**MEETING NOTICE
PLANNING AND ZONING COMMISSION
CITY OF BETTENDORF
MAY 18, 2011 AT 5:30 P.M.
CITY HALL COUNCIL CHAMBERS
1609 STATE STREET**

**MINUTES
PLANNING AND ZONING COMMISSION
APRIL 20, 2011
5:30 P.M.**

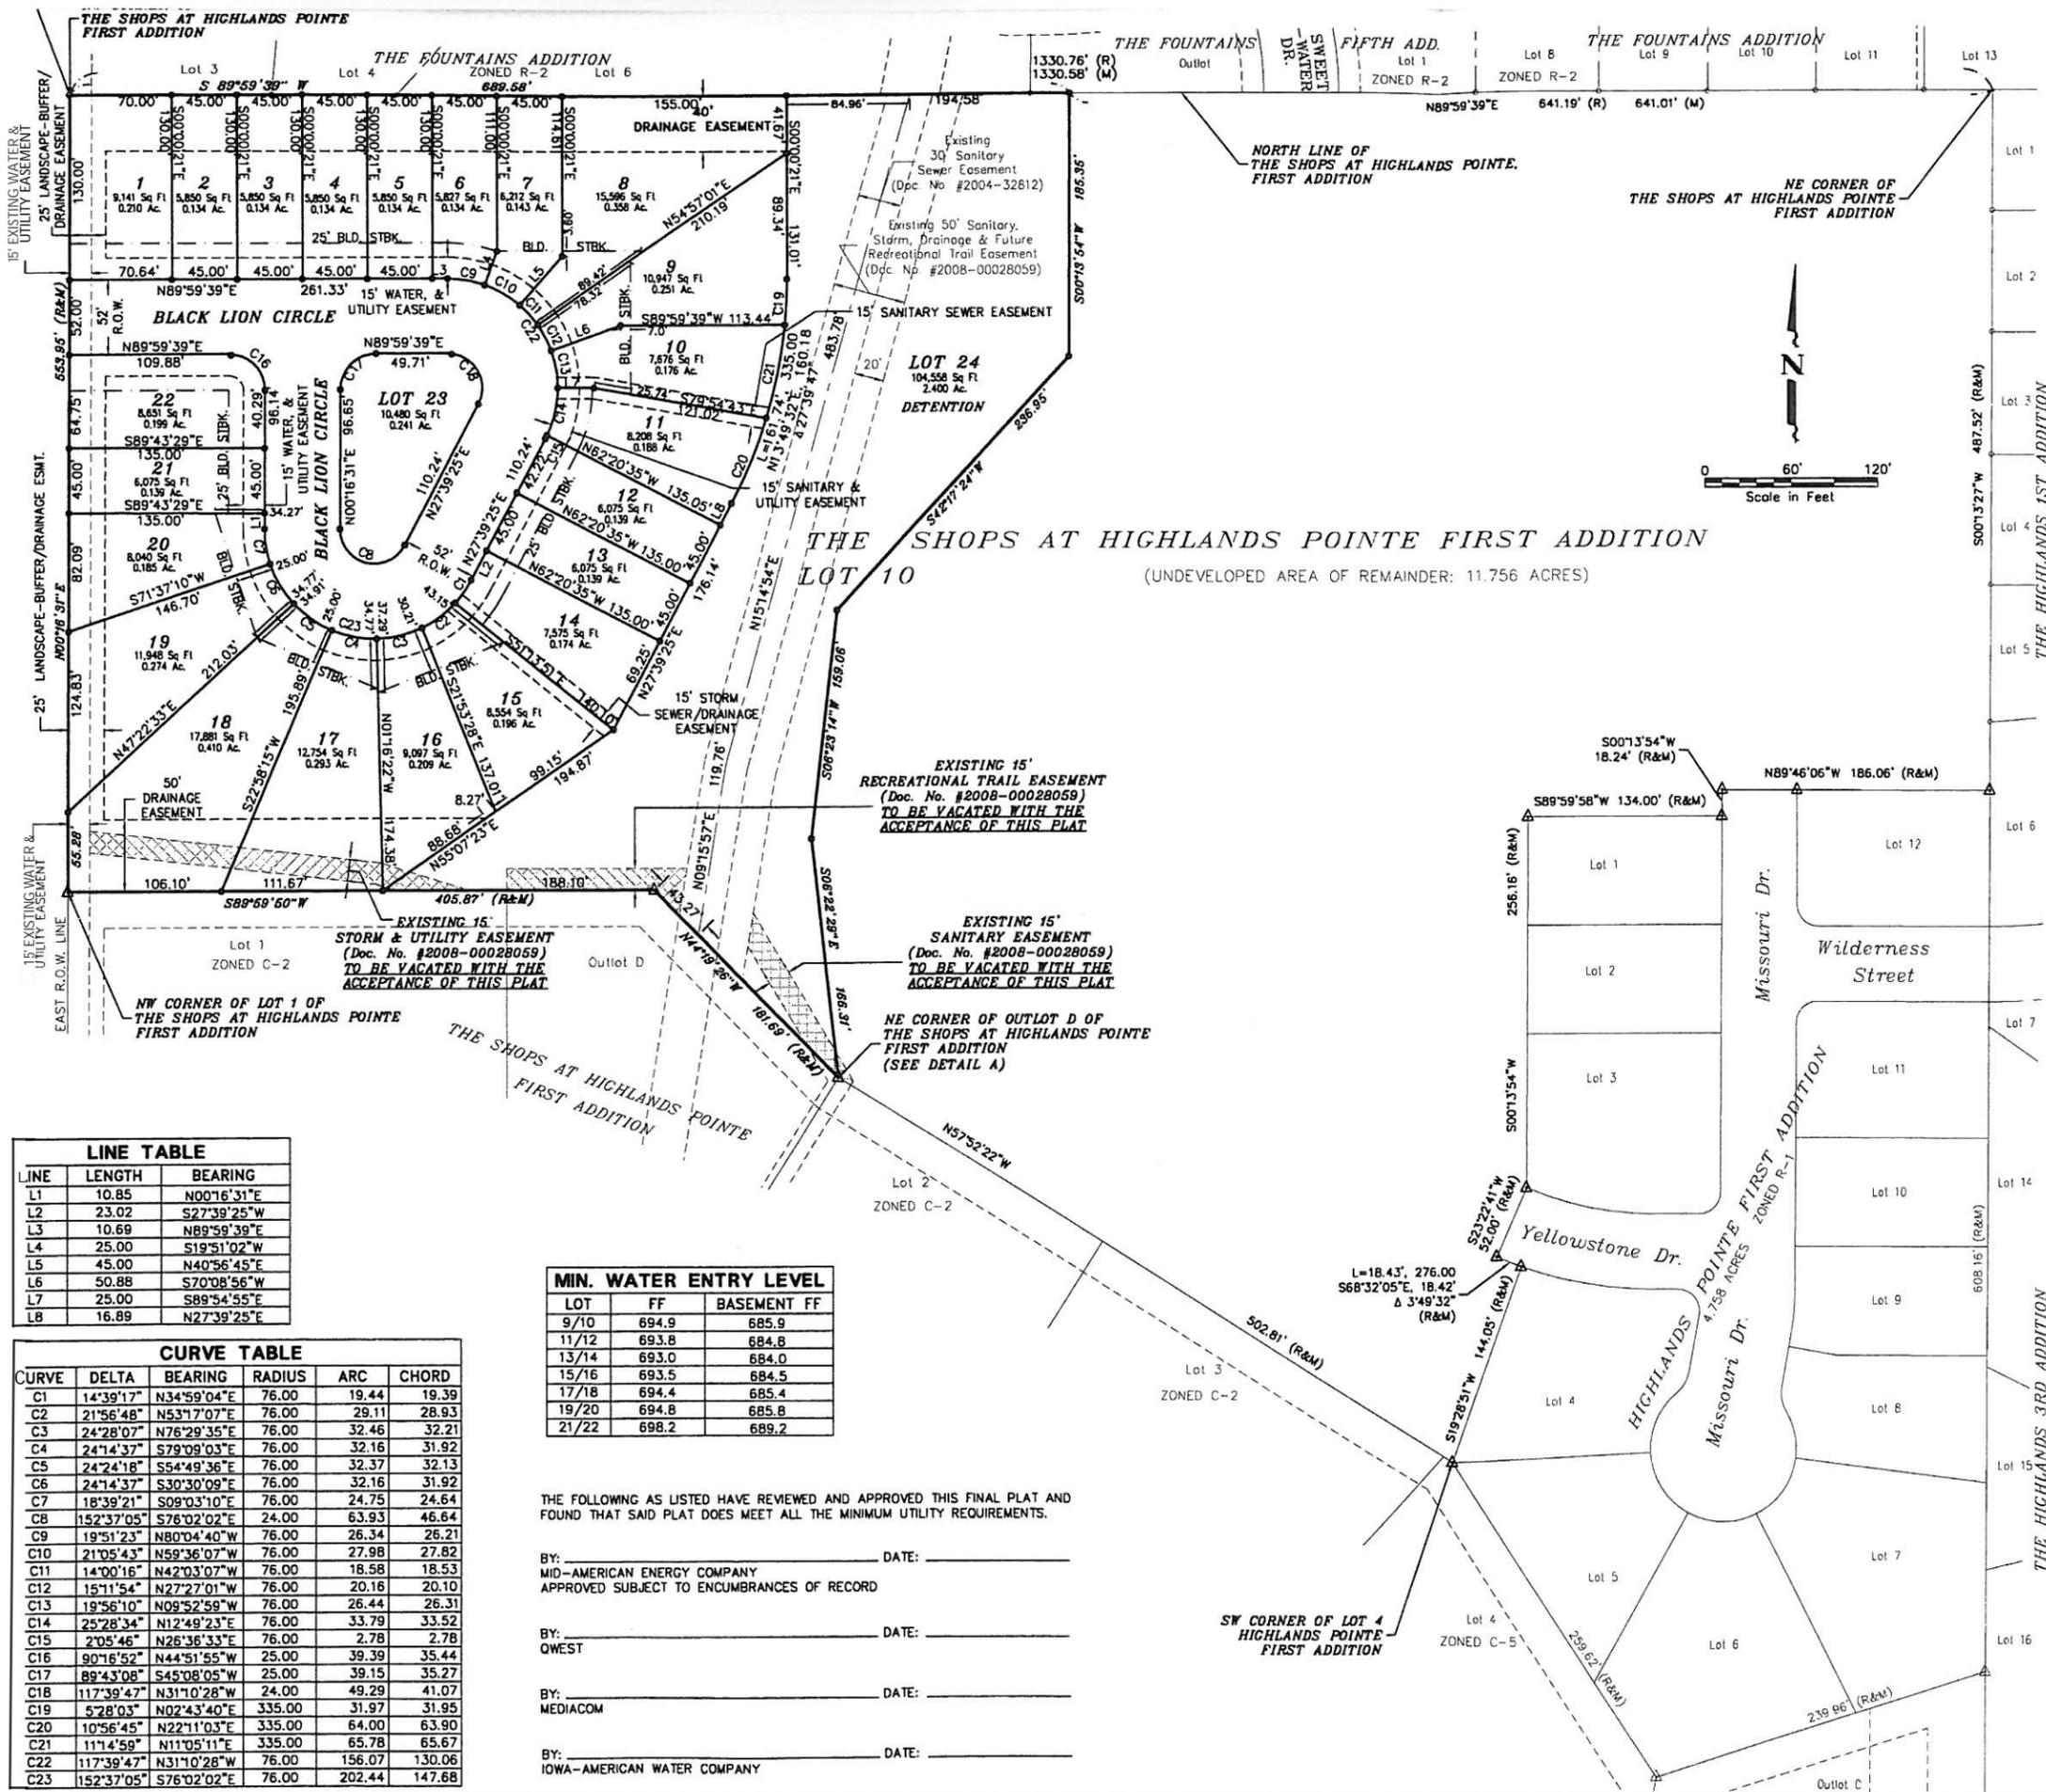
1. This approval does not waive any other state, federal, or local government provisions as required by law.
2. A screening of vegetation or a fence is required for Lot 1 and Lots 18-22 to act as a buffer from Devils Glen Road per City Ordinance. None of the vegetation may interfere with the drainage easement.
3. A minimum water entry level is needed for all walkout basement units. Show the minimum water entry level for any units that would be near an overflow of a storm sewer intake.
4. Provide maintenance agreements for Lots 23 and 24.
5. All lot access points must meet Fire Department standards for turning radii.
6. Storm water detention calculations must be approved by the City Engineer.
7. Vegetation other than turf grass may be placed in Lot 24 to help absorption of storm water into the soil.
